Re: Reevaluation Report  
Norfolk Southern Railroad Crossing (S1B-0250)  
Permit No. E65-973  
Penn Borough, Jeanette, and Hempfield Townships, Westmoreland County

**Attachment 3**  
**Response to Item 3**  
**PADEP comments on HDD S1B – 0250 Norfolk Southern RR**

**Well Location Map**  
**HDD# PA-WM1-0088.0000-RR**  
**Westmoreland County, PA.**

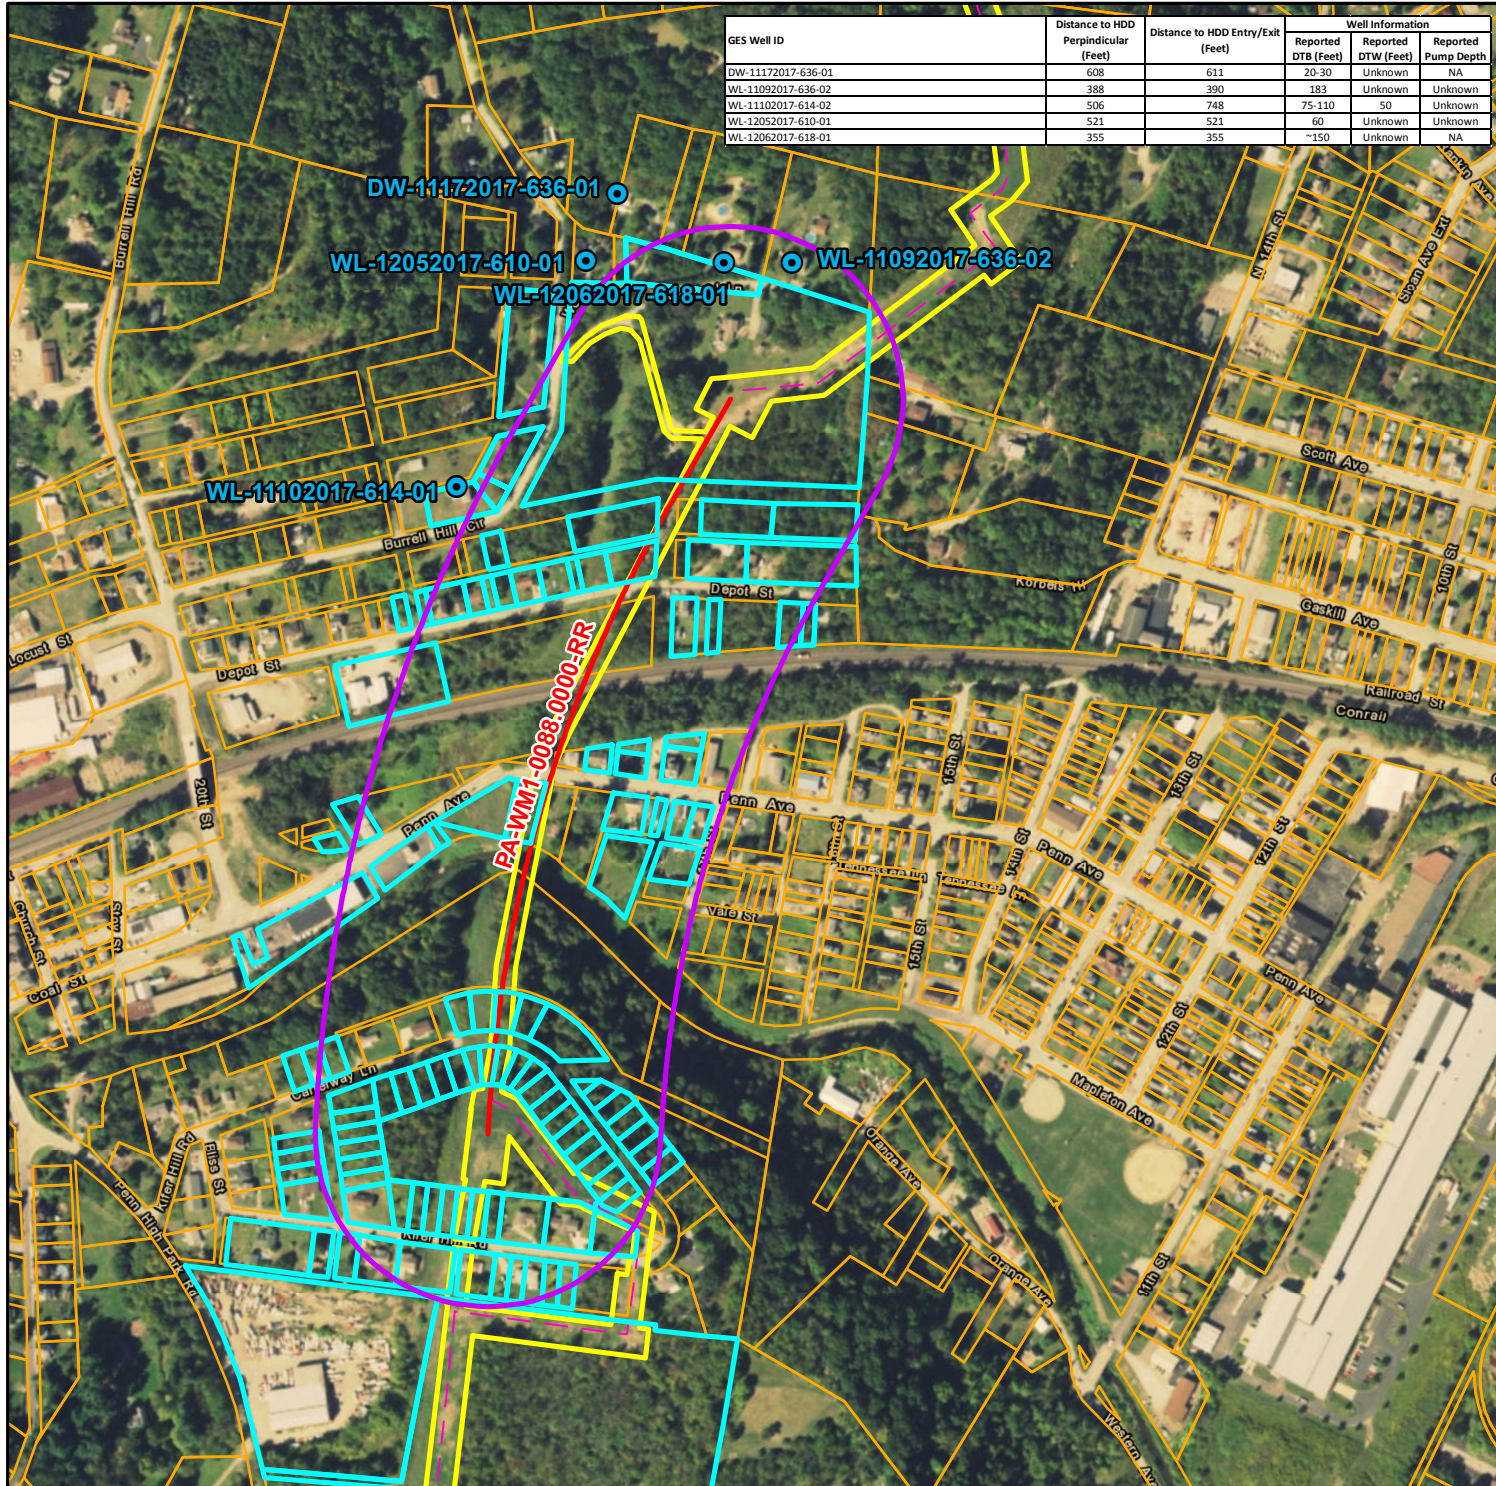
**Item 1 of your letter requests confirmation that SPLP has identified all water supplies within 450 feet of the HDD alignment, and**

**c. Provide the property owners' response to the notifications.**

**2. Provide discussion and consideration of potential risks to private water supplies.**

A water supply illustration is provided as Attachment 2. This illustration provides location information for the confirmed private water wells and areas serviced by public water supply surrounding the HDD profile.

As depicted on the attached water supply illustration, the two verified private water wells within 450 ft of the HDD profile are north and north-northwest of the north HDD entry/exit point, at 355 ft and 388 ft respectively.

These water wells are not located within the 150 ft area on either side of the HDD profile; therefore, based upon the locations of these wells, it is SPLP's opinion this HDD does not present a potential risk to private water supplies.
